UNION CARBIDE CORPORATION

November 17, 1978

Subj: PROPOSED AMENDMENT TO SPECIAL NUCLEAR MATERIAL
(SNM) LICENSE No. 639.

FIGURE 1

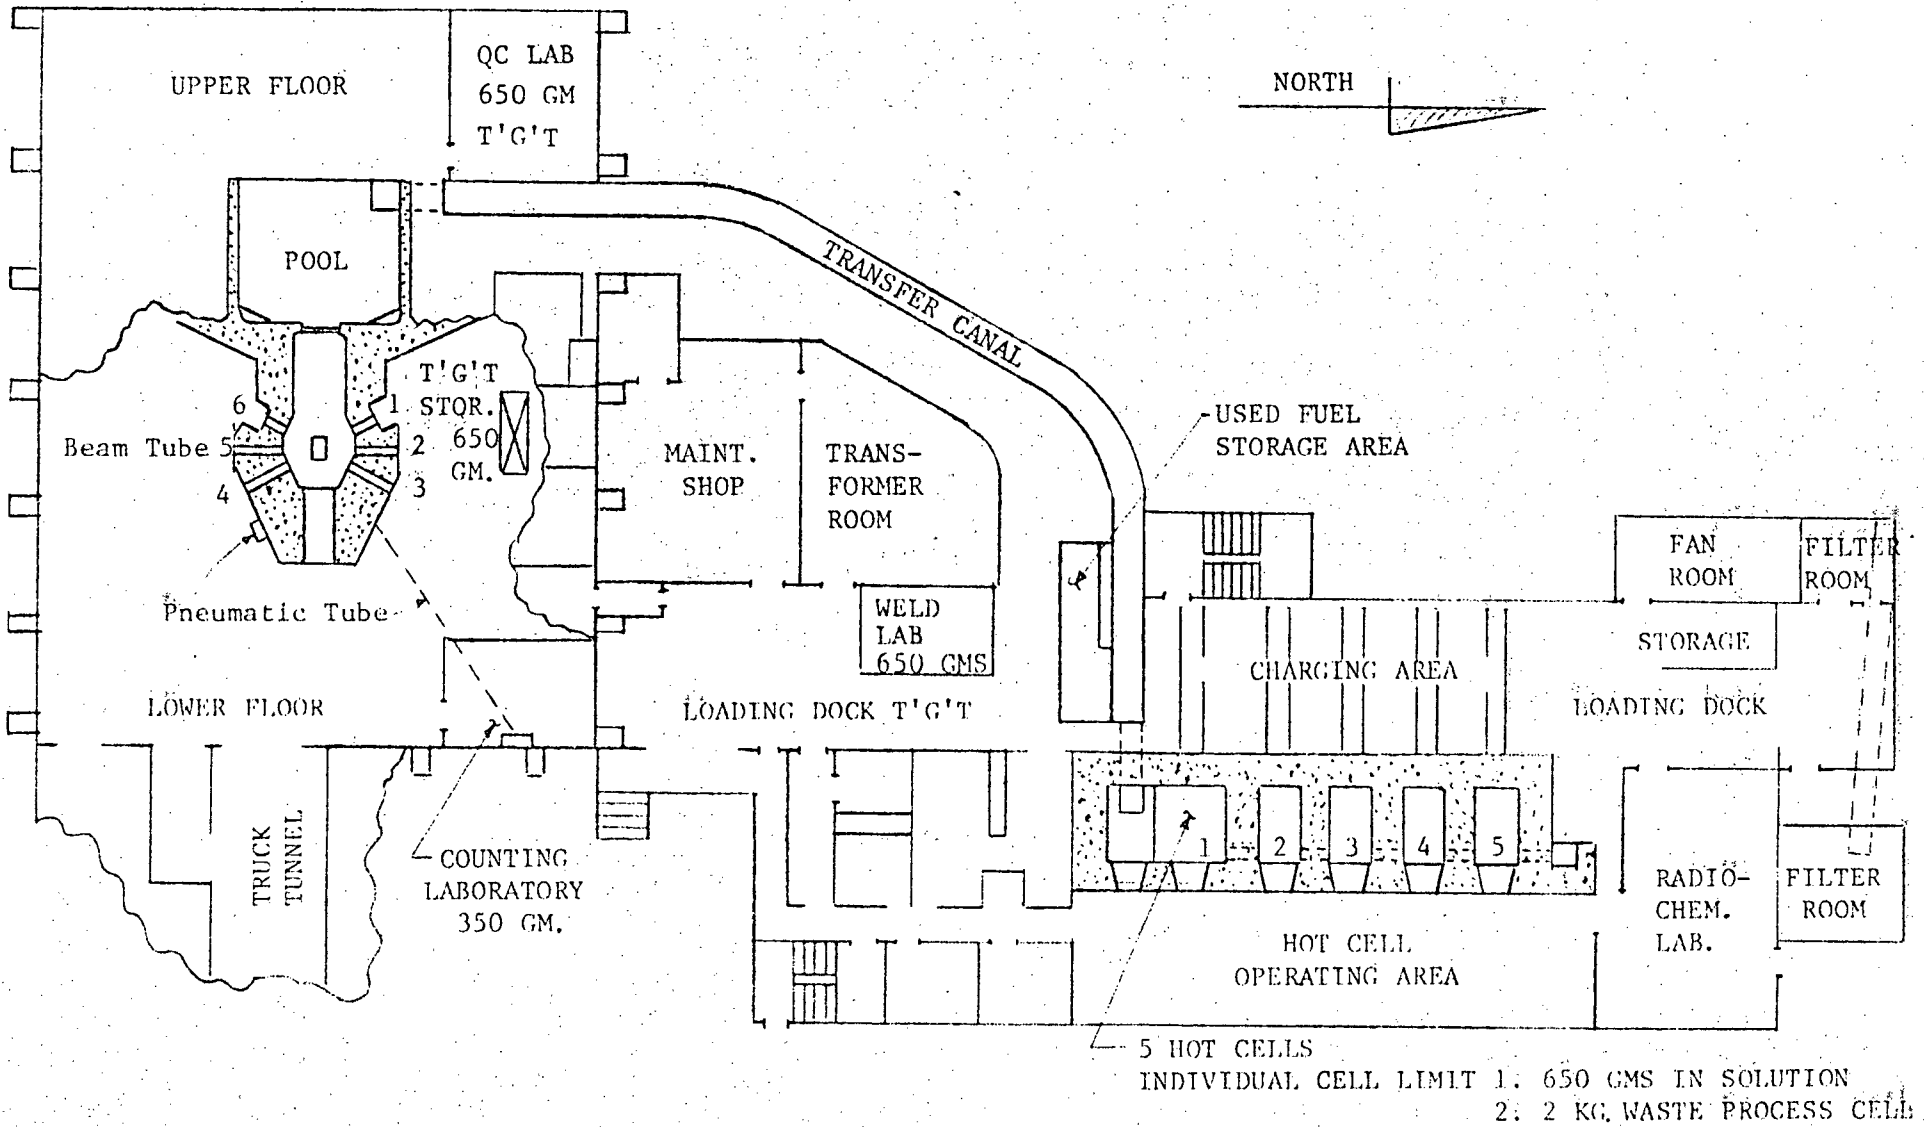
Revised floor plans are included to reflect the current storage locations and processing laboratories. A check in the amount of \$150.00 is enclosed to cover the administrative fee requirements of 10 CFR 170.31.

FIGURE 1A

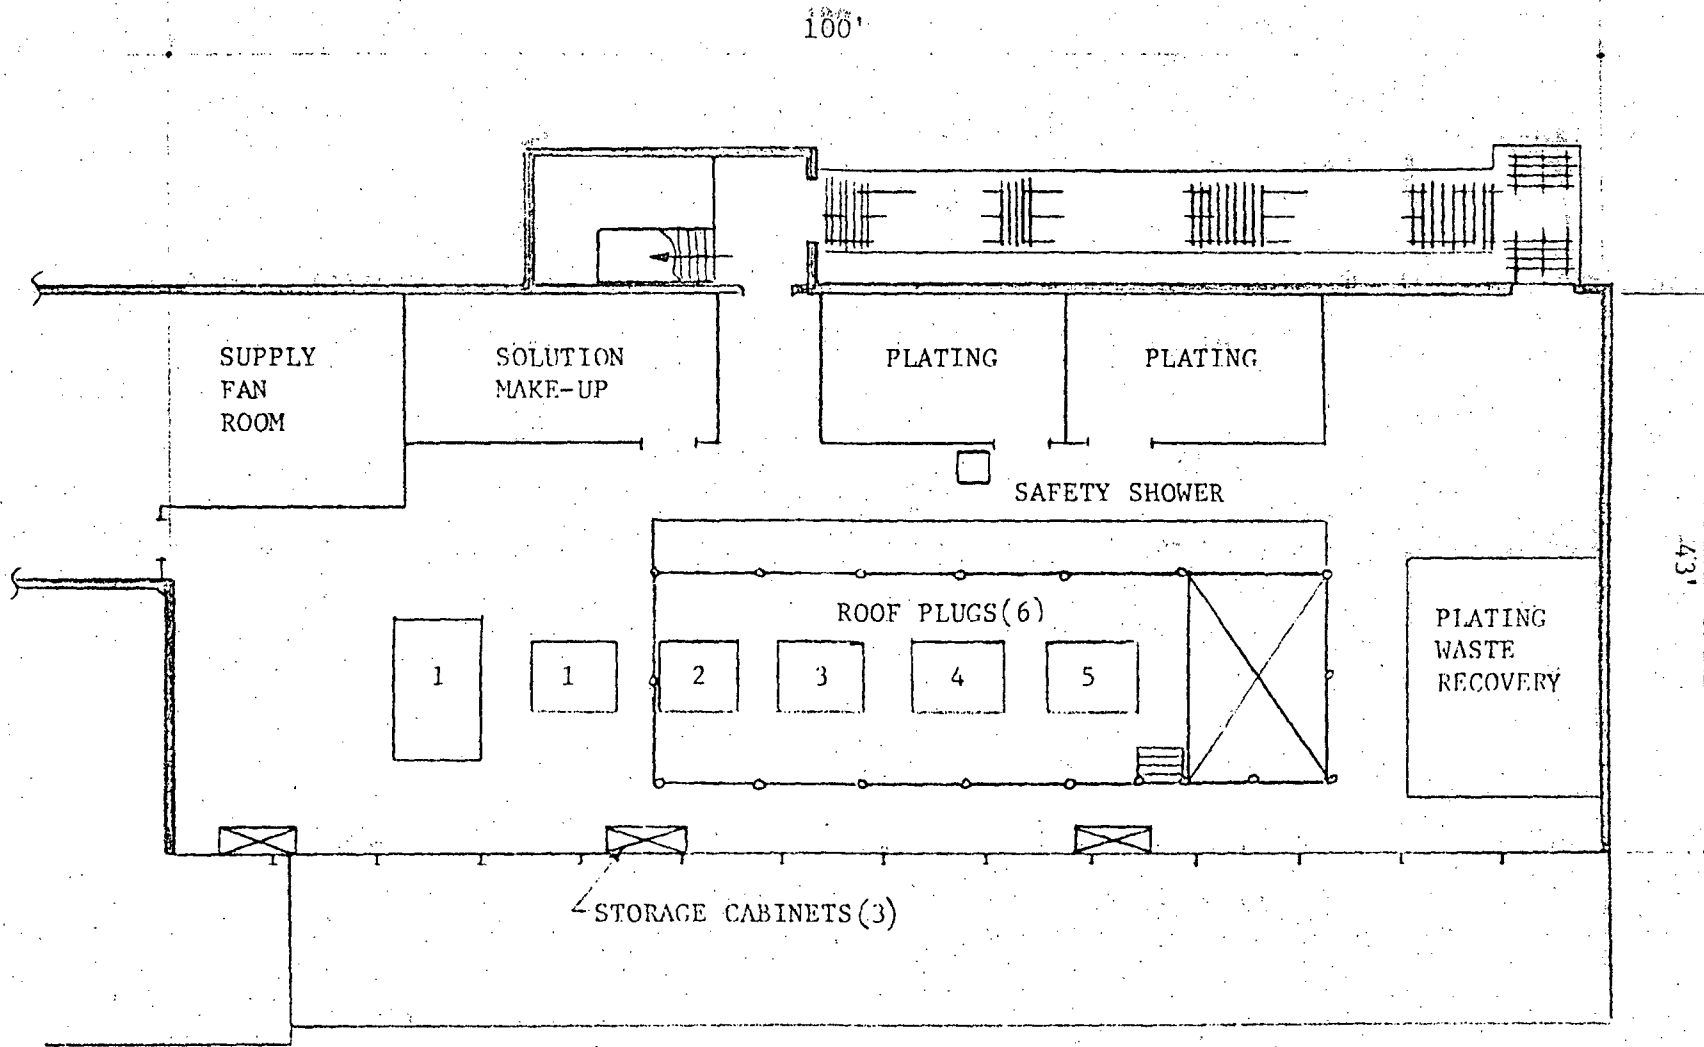
Uranium is stored in storage cabinets in the upper level of the hot laboratory (Fig. 1A). Material in liquid form is doubly contained. Storage cabinets are of fireproof construction, are separated by a minimum distance of three feet and are fastened to prevent inadvertent movement. All cabinets are locked and keys are in the custody of the SNM custodian for the area. Criticality control is implemented by limiting the quantity of SNM in solution to 350 grams per storage cabinet. This limit allows a safe margin below the single parameter limit of 760 grams U-235 in uniform aqueous solutions specified in the ANSI N16.1-1969 standard even

- "A.3. Unirradiated SNM in solution shall not exceed 350 grams in a single laboratory."
- "A.4. SNM, as an oxide, encapsulated for irradiation shall not exceed 650 grams in a single laboratory. When SNM is in process in the plating lab (Fig. 1A), it can be either as a solid (oxide) or in solution (electrolyte 15 gms/liter, H:U  $\approx$  1500) and the quantity of either form shall be governed by the formula:
